1.0 APPLICATION SUMMARY

Applicant: BG Ventures LLC c/o Greg Soulliere

Introduction Summary:
 PD 21-0123 was approved in 2021 to allow for a mixed-use development to include mini warehouse and single-family residential uses. The applicant is requesting a modification to remove a condition of approval that was required to meet the mixed-use requirement of the Future Land Use category.

PRS 26-0387: MIXED-USE EXHIBIT

8.2 Proposed Site Plan (Full)

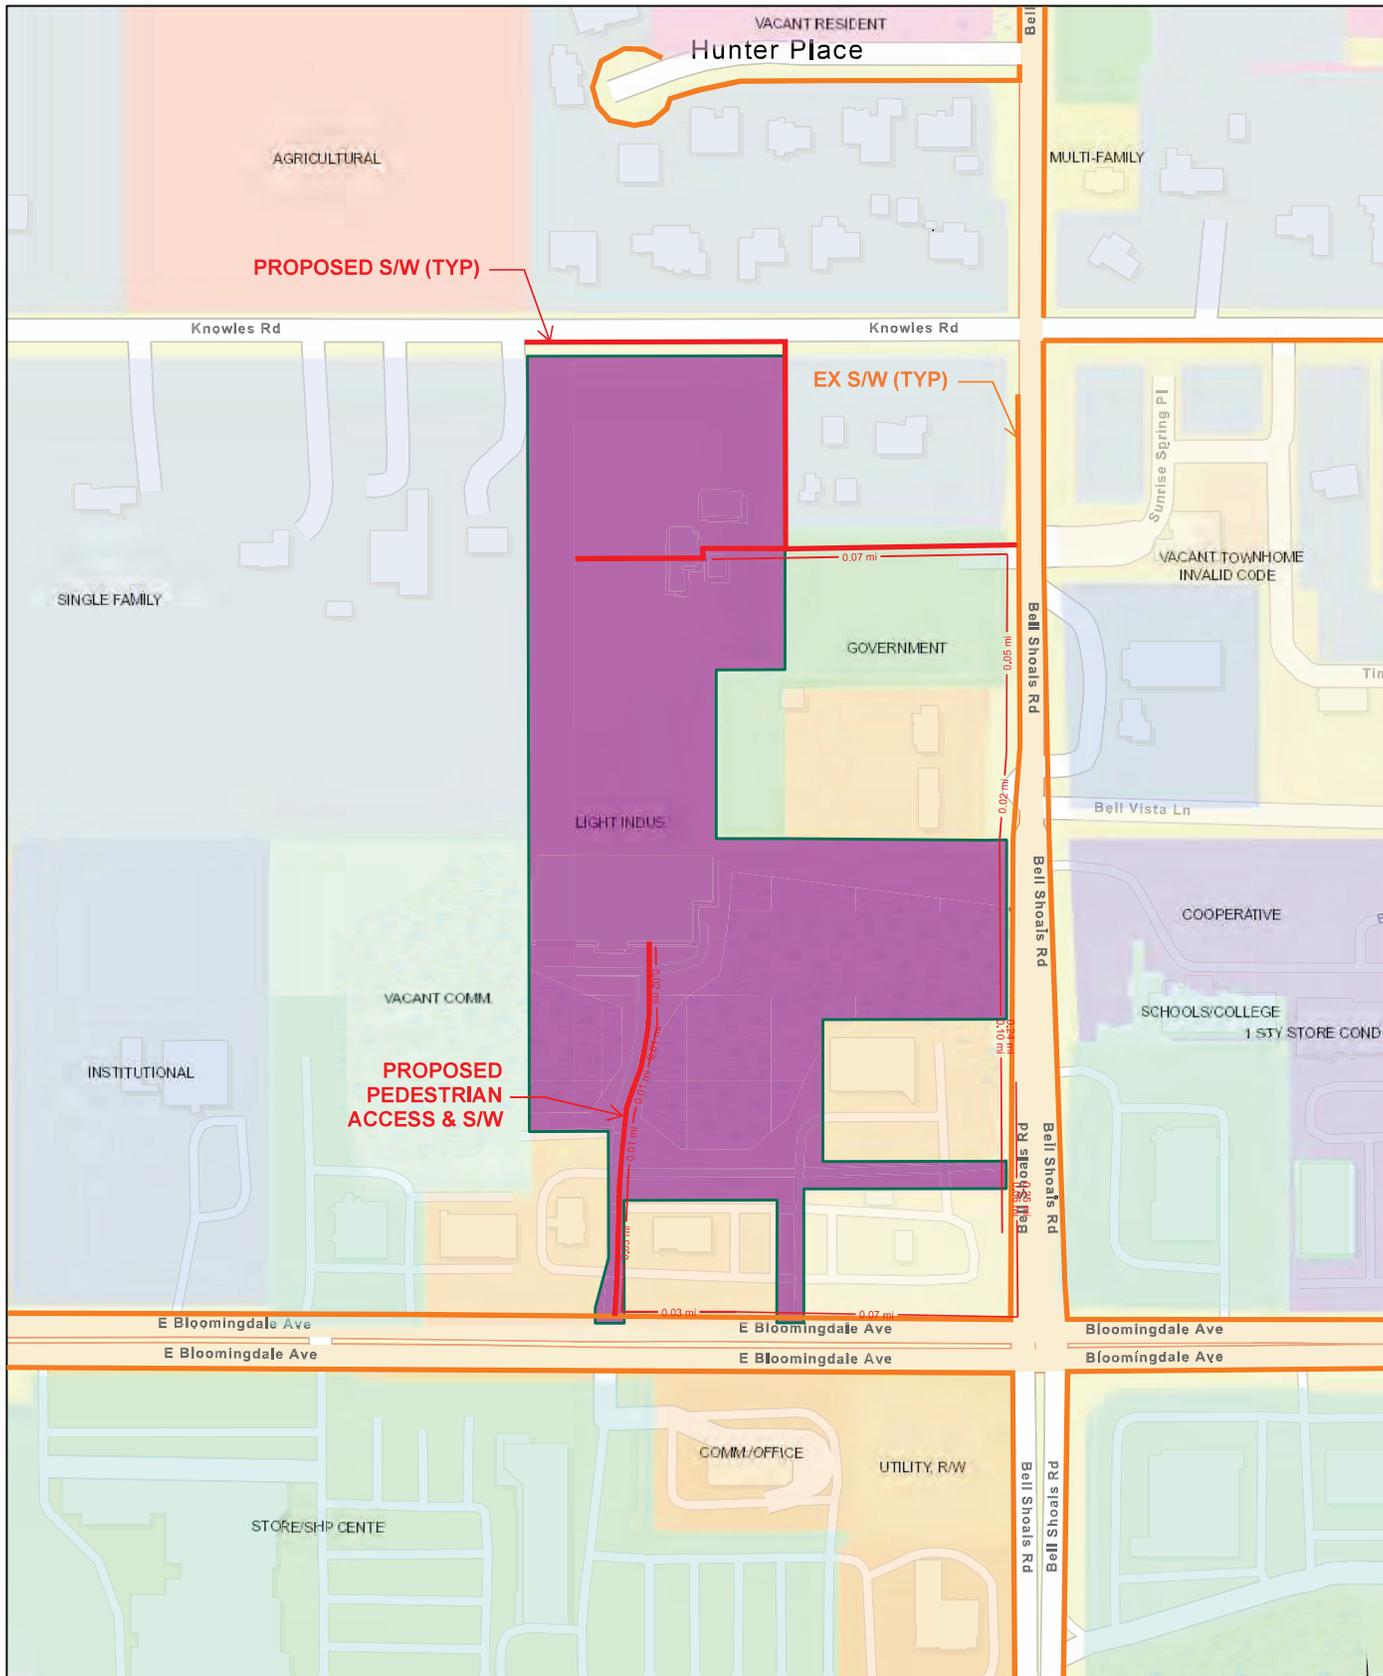
Approval - . Approval of the request, subject to the conditions listed, is based on the revised general site plan submitted ~~April 27, 2021~~ February 13, 2026.

The applicant is proposing to change a Future Land Use (FLU) policy related condition (1.1) which requires issuance of a Certificate of Occupancy for one home prior to construction of the self-storage facilities. Modification of this condition has no impact on the trip generation potential of the site. Also, the applicant has added an internal sidewalk facility (which staff notes is already required pursuant to Sec. 6.03.02 of the LDC and helps the applicant meet other FLU related requirements). Since staff does not review the placement or design of the sidewalk at the time of zoning review (but a PD is a binding site plan), staff has included the above condition to clarify that review of site features (such as the newly added sidewalk) may need to be modified from that shown on the PD site plan at the time of plat/site/construction plan review to meet current technical standards and other requirements.

FIGURE 2. TECHNICAL DRAWING – TD-2

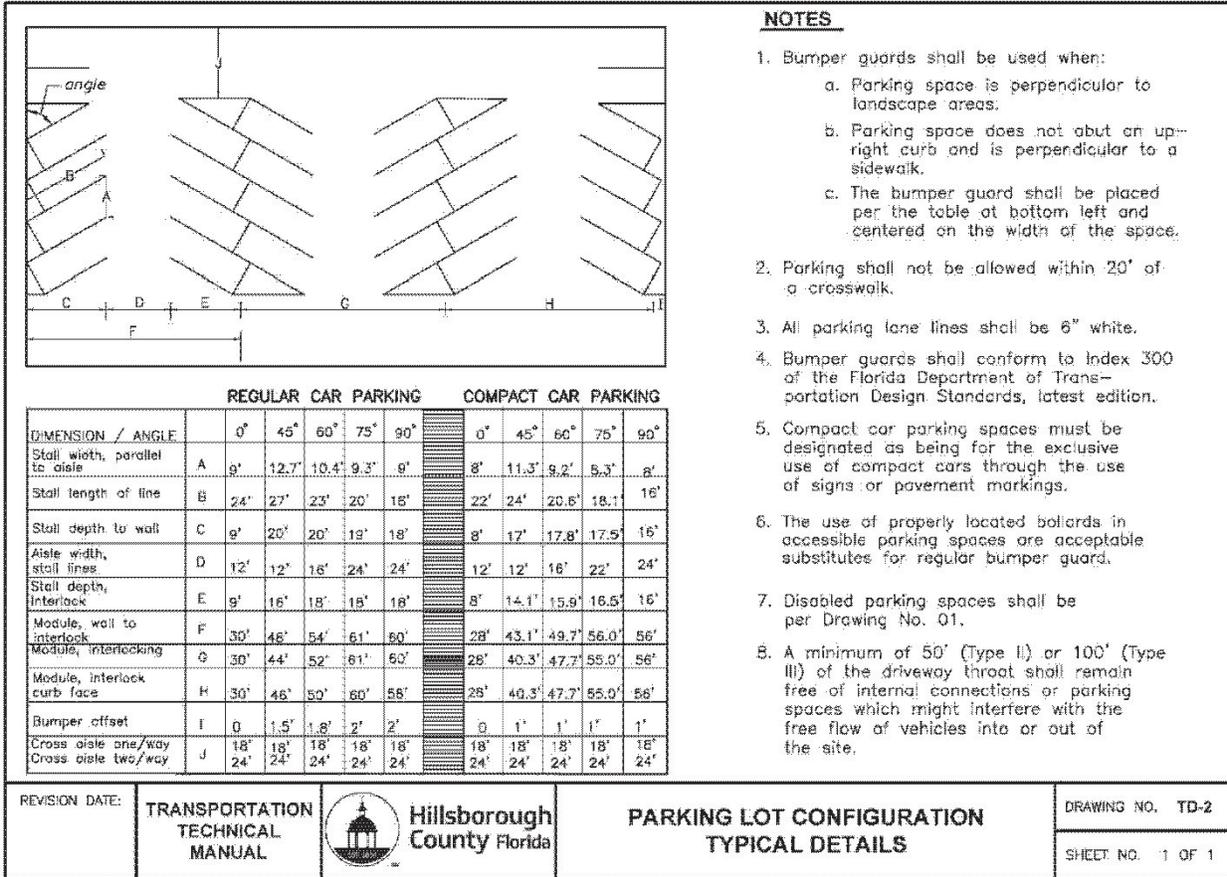
This request is a design exception to the Hillsborough County Transportation Technical Manual for TD-2, Minimum Commercial Drive Aisle Width. Per TD-2, as illustrated in Figure 2, the minimum commercial drive aisle width is 24 feet. However, the internal driveway connection between the existing enclosed storage building and the proposed new building is requested to be 20 feet, as shown in Figure 3. The justifications to the request are as follows:

FIGURE 3. PROPOSED 20 FOOT DRIVEWAY WIDTH

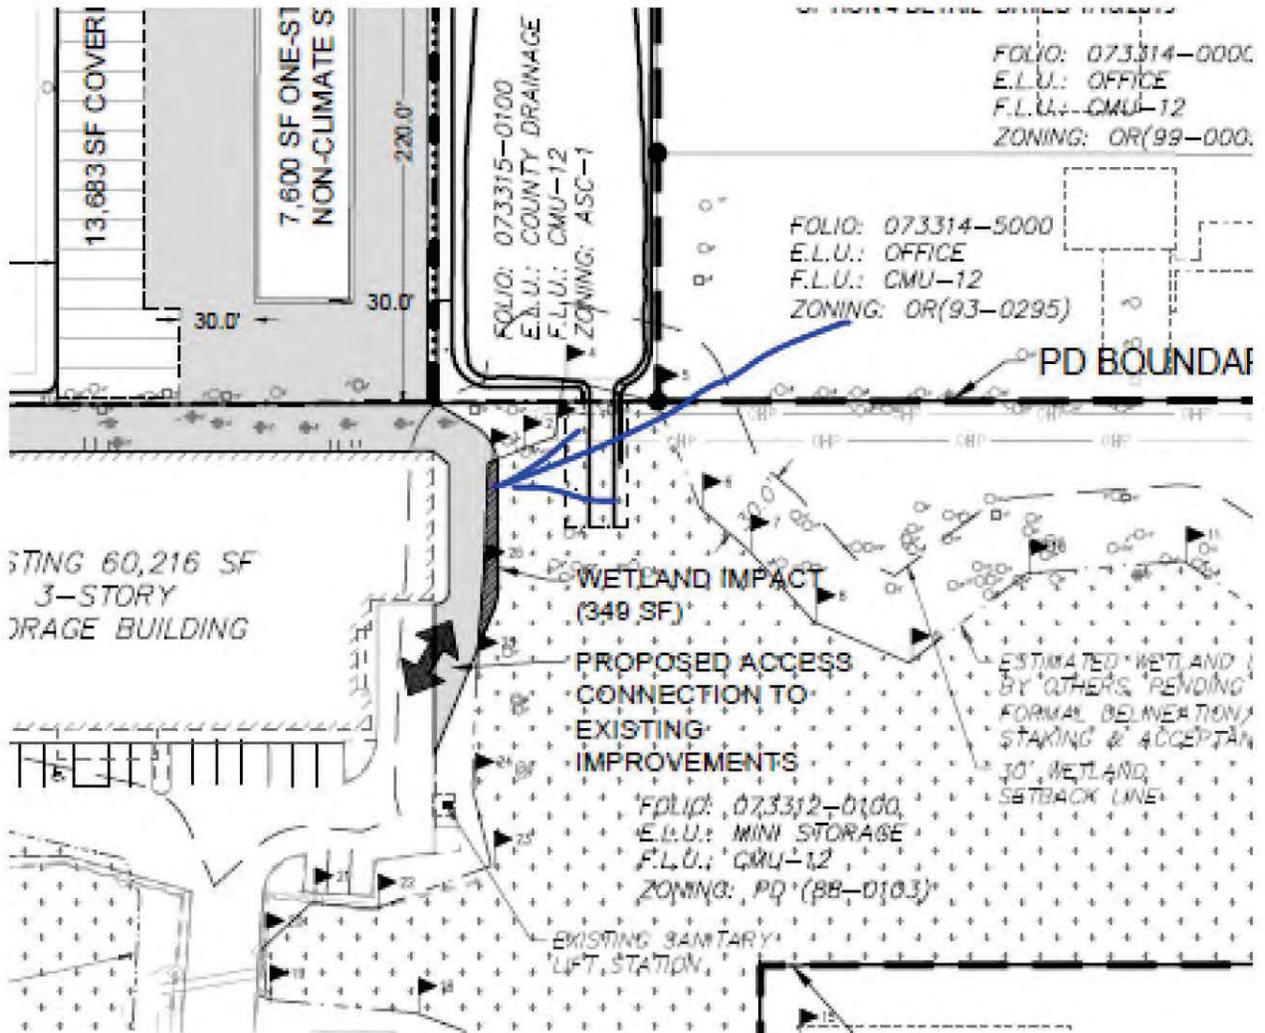
1. There is no parking along this commercial drive aisle.
2. This connection only provides internal connection within the PD and therefore would have very limited daily volume.
3. The FDOT Design Manual allows for 10-foot travel lanes when the design speed is 35 mph or less in suburban and urban areas, as shown in Figure 4.
4. The 20-foot drive isle requires a 349 SF wetland impact. Increasing the driveway width could add significant, additional impacts to the wetland. EPC has reviewed and approved the limited encroachment to these wetlands to accommodate this enhanced driveway based

The County Engineer has reviewed zoning modification application # 26-0387 and determined the changes to be de minimis. As such, the previous approval shall stand.

Figure 2. Driveway Spacing

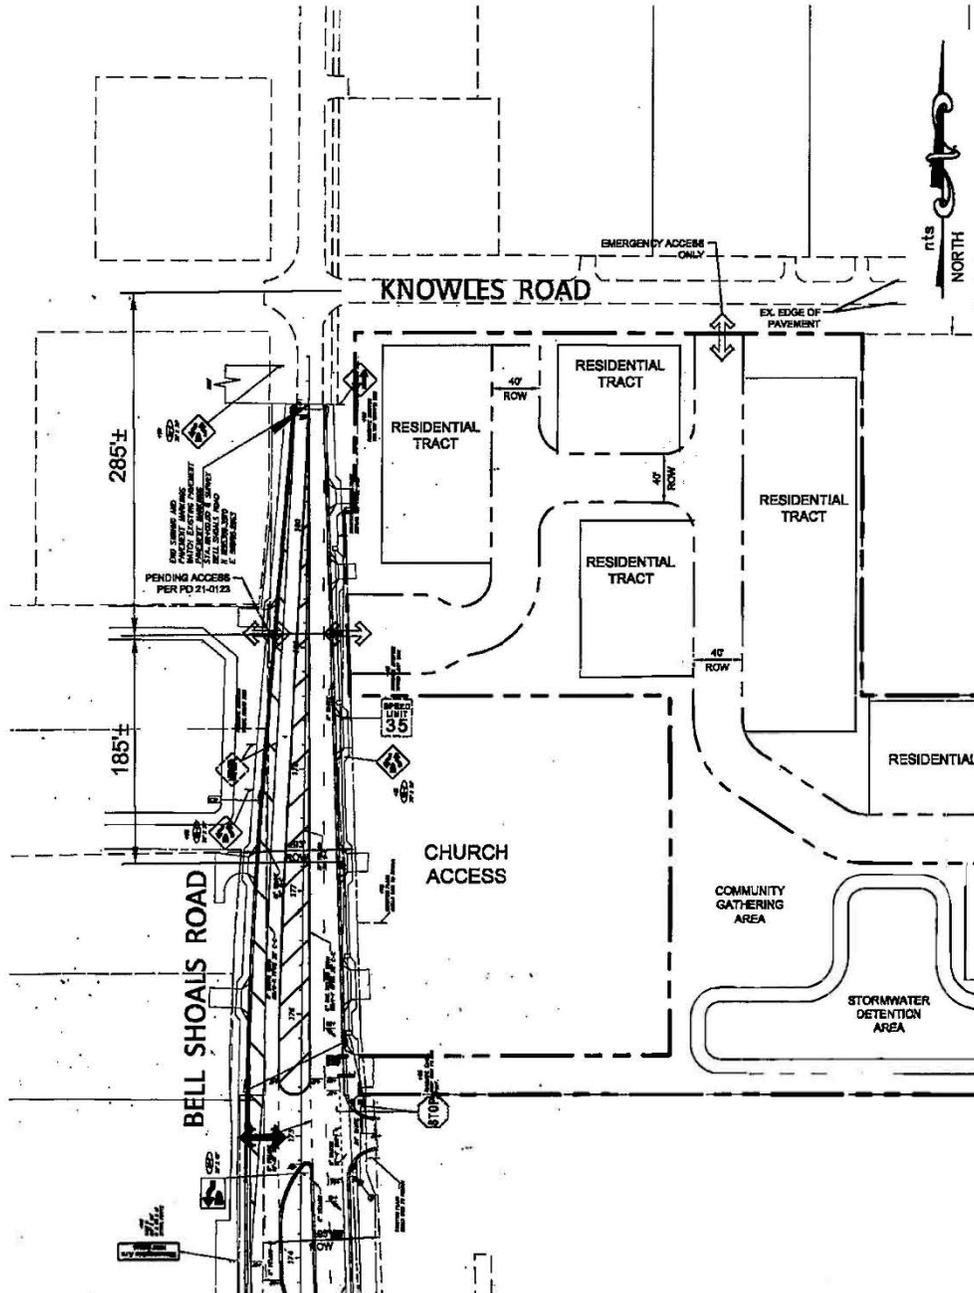
The access to Bell Shoals Road from the project is to align with the proposed access to serve the townhome project on the east side of Bell Shoals Road. The subject access is approximately 285' feet from Knowles Road and approximately 185' feet from the office driveway, as illustrated in Figure 2.

The County Engineer has reviewed zoning modification application # 26-0387 and determined the changes to be de minimis. As such, the previous approval shall stand.

FIGURE 3. PROPOSED 20 FOOT DRIVEWAY WIDTH

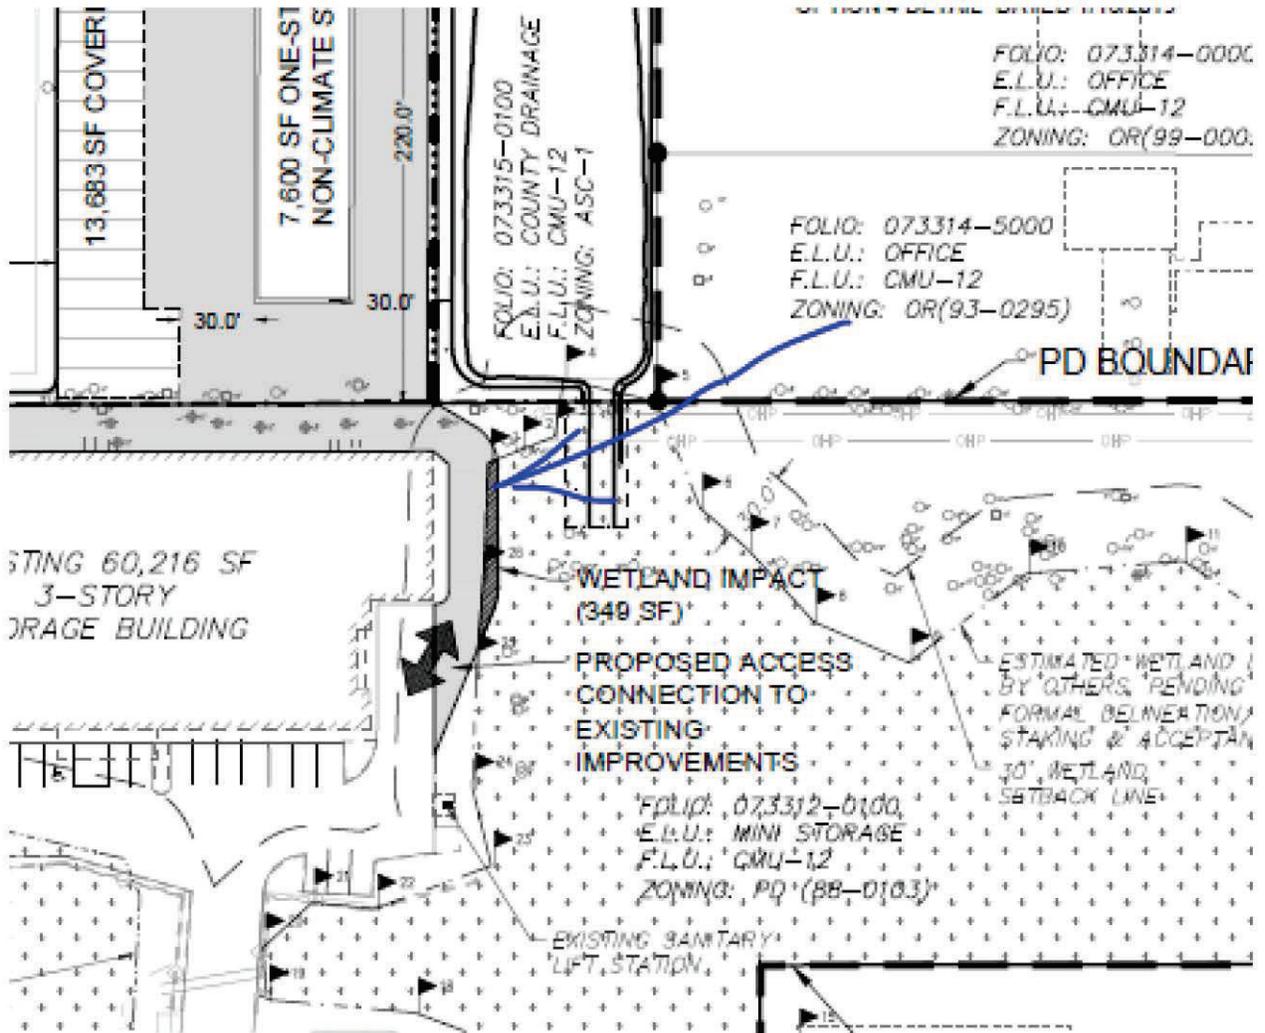
This request is a design exception to the Hillsborough County Transportation Technical Manual for TD-2, Minimum Commercial Drive Aisle Width. Per TD-2, as illustrated in Figure 2, the minimum commercial drive aisle width is 24 feet. However, the internal driveway connection between the existing enclosed storage building and the proposed new building is requested to be 20 feet, as shown in Figure 3. The justifications to the request are as follows:

1. There is no parking along this commercial drive aisle.
2. This connection only provides internal connection within the PD and therefore would have very limited daily volume.
3. The FDOT Design Manual allows for 10-foot travel lanes when the design speed is 35 mph or less in suburban and urban areas, as shown in Figure 4.
4. The 20-foot drive isle requires a 349 SF wetland impact. Increasing the driveway width could add significant, additional impacts to the wetland. EPC has reviewed and approved the limited encroachment to these wetlands to accommodate this enhanced driveway based

The County Engineer has reviewed zoning modification application # 26-0387 and determined the changes to be de mimimis. As such, the previous approval shall stand.

Figure 2. Driveway Spacing

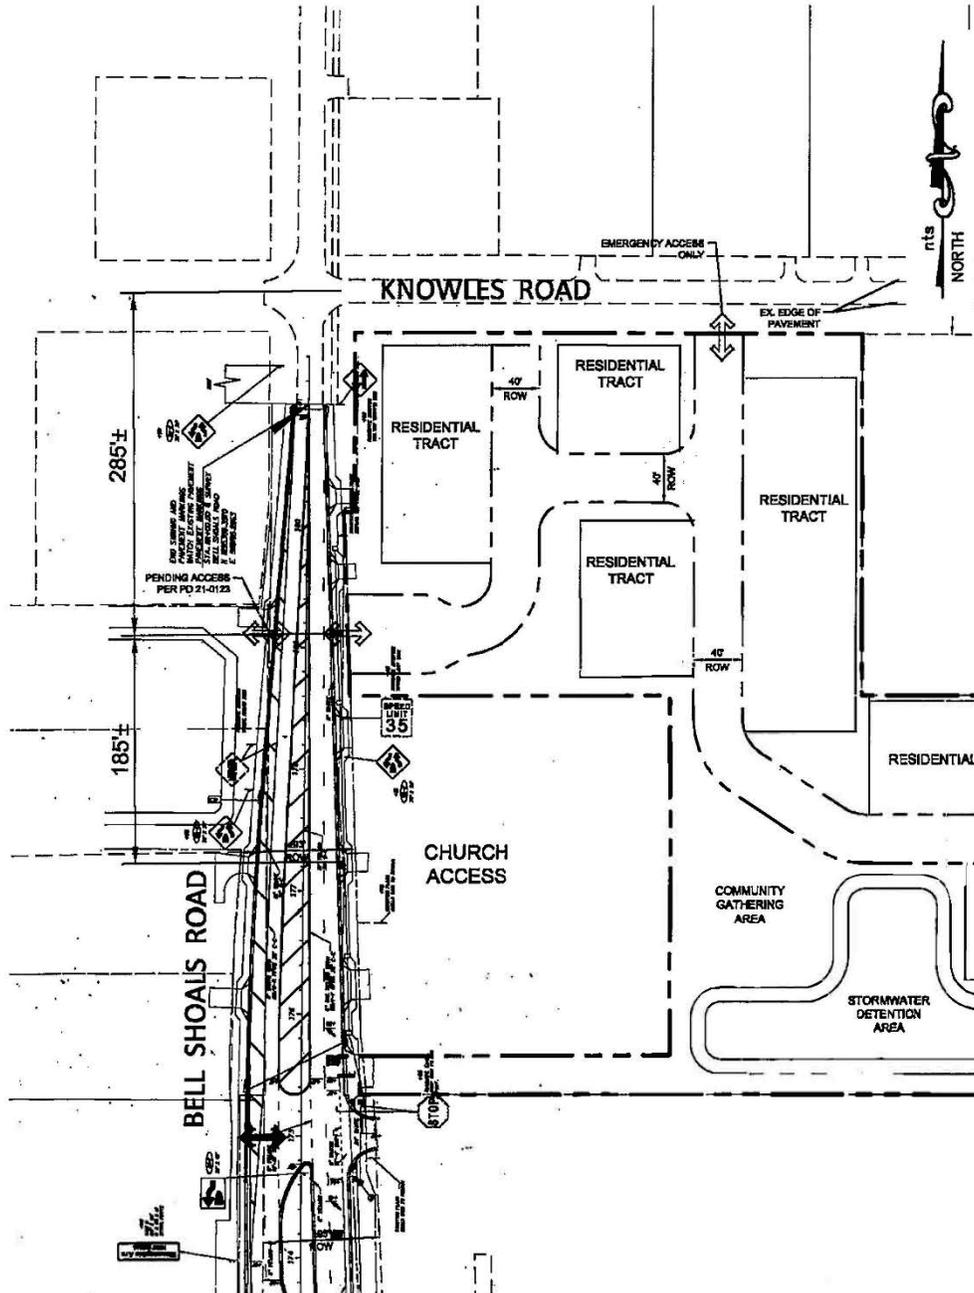
The access to Bell Shoals Road from the project is to align with the proposed access to serve the townhome project on the east side of Bell Shoals Road. The subject access is approximately 285' feet from Knowles Road and approximately 185' feet from the office driveway, as illustrated in Figure 2.
